CERTIFICATE OF APPROPRIATENESS

Property: 613 Arlington Street, Lot 10, Block 279, Houston Heights Subdivision. The property includes a historic 1,232 square foot one-story wood frame single-family residence and a detached garage situated on a 6,600 square foot (50' x 132') interior lot.

Proposal: Alteration – Construct a 2,834 square foot two-story addition and attached 508 square foot two-car alley loading garage at the rear of the original structure.

HAHC Action: Approved

EAST ELEVATION – FRONT FACING ARLINGTON STREET

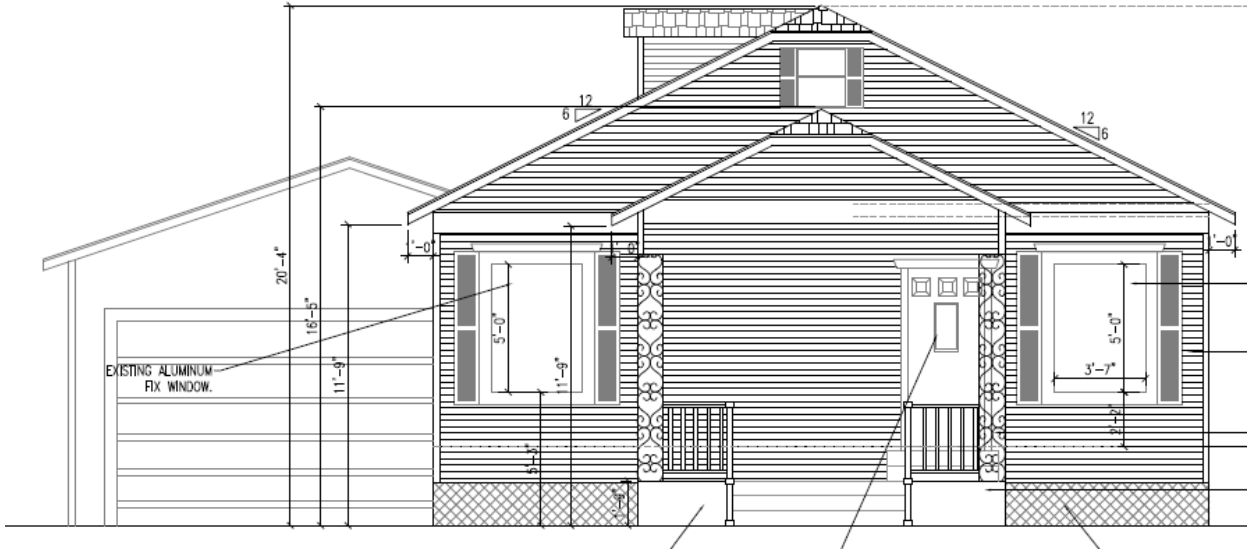
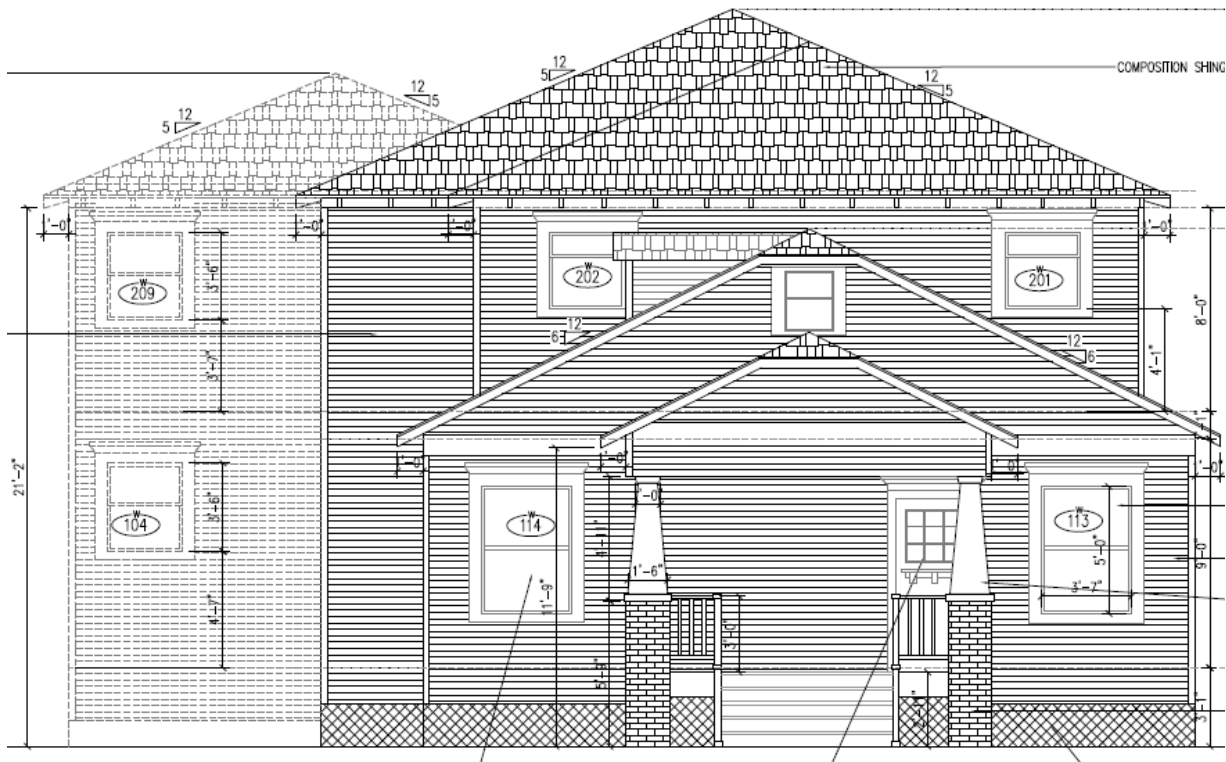
Agenda # 21 – 613 Arlington – I OBJECT to the granting of a Certificate of Appropriateness for this property. The proposed massing volume is not compatible with typical contributing structures in the district. The proposed addition is more than 2 times the volume of the existing historic structure and is proportionally out of scale.
